# Audit of Prince of Wales Road eastbound cycle track

Camden Cycling Campaign, 3rd December 2020

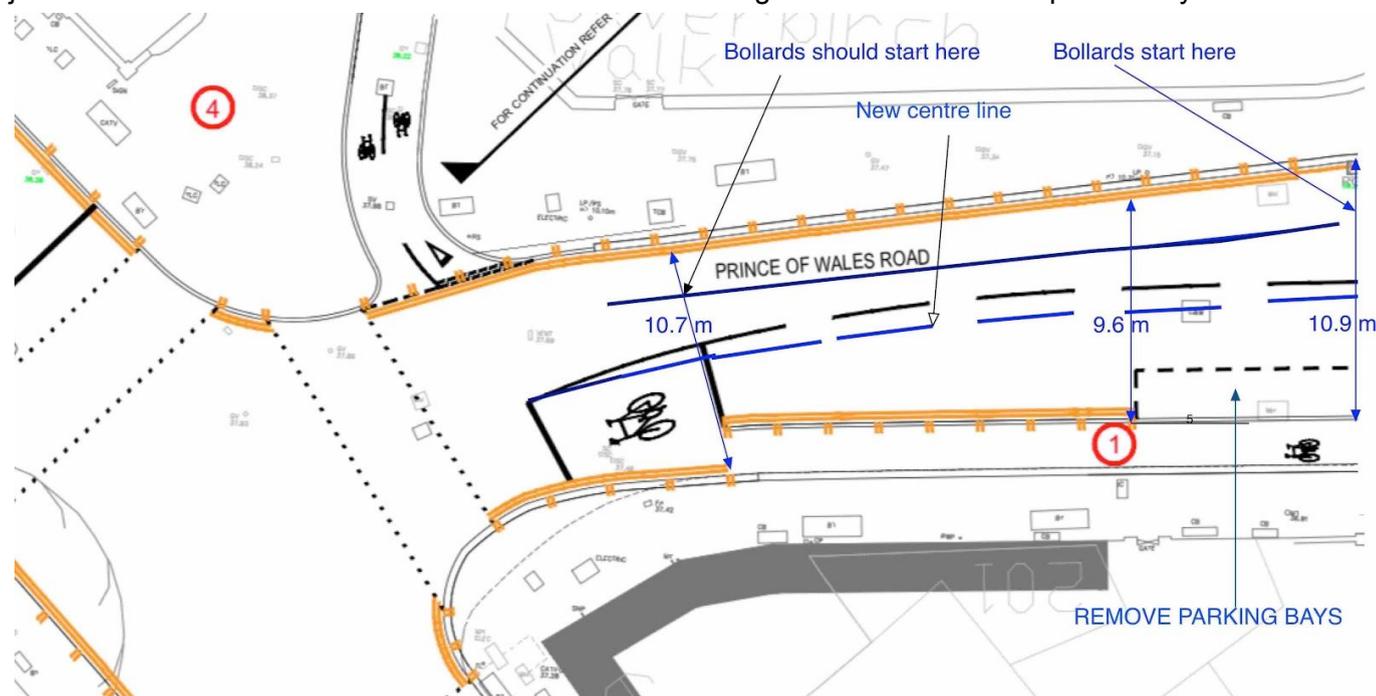
The eastbound cycle lane does not start until about 30m east of the junction with the effect that cyclists have no protection from motor vehicles following and passing them. This is particularly important at this junction because of the need to ensure that motors turning into PoW will leave space for cycles.

We have measured the width of PoW from the northern kerb to the edge of the westbound cycle track. These measurements are shown in blue on the drawing above. Currently the bollards start opposite the start of a short section of parking to the west of a driveway (not shown). We propose that this short section of parking should be removed (two parking spaces). This would enable the centre line to be adjusted to make room for the 2-m wide eastbound cycle lane to start from opposite the westbound ASL box where the available width is 10.7m – 4m for the two cycle lanes and 6.7m for the two motor lanes.

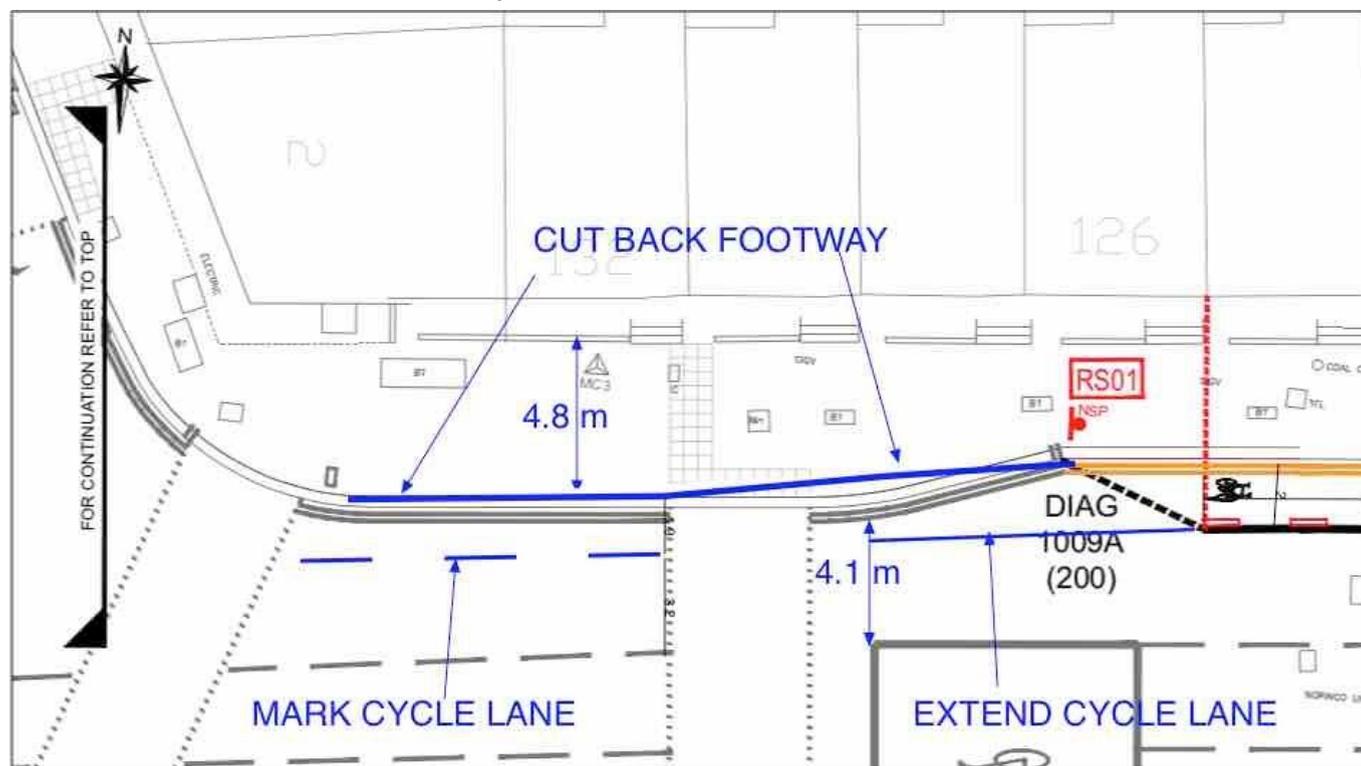
On the approach to Malden Road, the eastbound cycle lane narrows suddenly from 2.9m to 1.2m – as shown in blue on the above photo. The kerb extension needs to be cut back by 0.8m so that the width of the cycle lane is 2m and the bollards can go right up to the start of the ASL box.
